**STAFF REPORT - DESIGN REVIEW E
FINDINGS AND RECOMMENDATION**

FILE NUMBER: DRE/TR 19-26000064

APPLICANT: Robert Gibson, Palindrome Communities

PROPOSAL: Type III Design Review E for the development of a mixed-use project with five buildings, providing 435 dwelling units and approximately 10,500 square feet of commercial space with associated site improvements including landscaping, a single-level subterranean parking structure, and publicly accessible plaza; and Type II Tree Removal for the removal of 50 regulated trees.

Diagram B.1: Civic Drive Street Type Cross Section

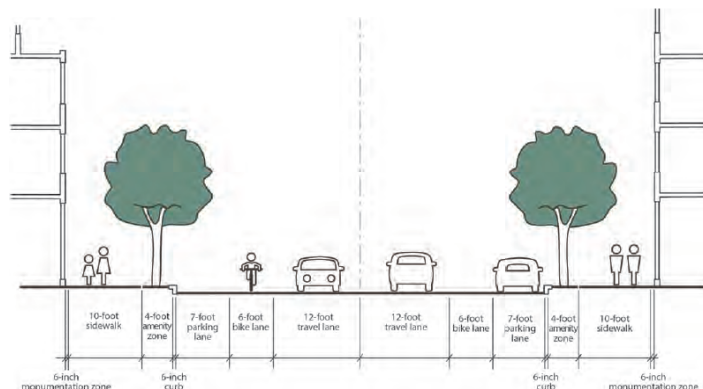
NW Civic Drive is classified as a Major Collector and has a special cross-section of 80 feet as shown in the Civic Neighborhood Plan District (4.1243.B.). NW Civic Drive currently has 80 feet of right of way, and no dedication is required at this time.

NW Civic Drive’s special cross-section requires a 10-foot sidewalk, 4-foot amenity zone, 7-foot parking lane, 6-foot bike lane, and 12-foot travel lane to centerline. The applicant is proposing a 5-foot amenity zone and a 5-foot sidewalk behind the curb, with sidewalk connections to the building entrances. This is not an adequate width sidewalk for the main retail street in the Civic Neighborhood Plan District. The 10-foot sidewalk design is intended to handle higher amounts of pedestrian traffic and allow for occasional retail and café operation on the sidewalk. Given the proximity to the MAX station, the 10-foot sidewalk is needed for pedestrian circulation in a location that has high pedestrian demand and future possible pedestrian conflicts. The applicant will need to construct additional sidewalk between the building and the existing sidewalk per the cross-section from the Civic Neighborhood Plan District, as follows.

Civic Neighborhood Local Street - 2018 standard

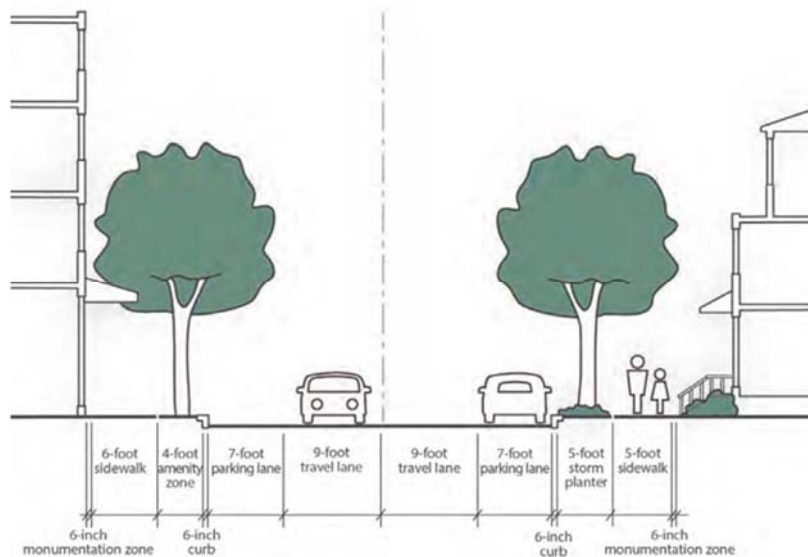
NW 13th Street is classified as a Civic Neighborhood Local Street by the Civic Neighborhood Plan District Design Manual. A Civic Neighborhood Local Street has a 58-foot right of way with 29 feet of right of way to centerline, as shown in the following drawing. The applicant is proposing a 21-foot dedication that would provide 27 feet of right of way to centerline, which matches the old standard in place before January 2019 when planning for this project began. The proposal includes a 10.5-foot sidewalk with tree wells, a 6-inch curb, and 16 feet of pavement to centerline. These dimensions are consistent with the 2018 standard and provide adequate pedestrian space on the sidewalk for a dense urban area and enough vehicle space for a 7-foot parking lane and a 9-foot travel lane, which is adequate for traffic circulation on a local street. As the City standards were updated during project development with the intent of simplifying the number of cross-sections and not due to deficient cross-section dimensions, the proposed cross-section is approved.
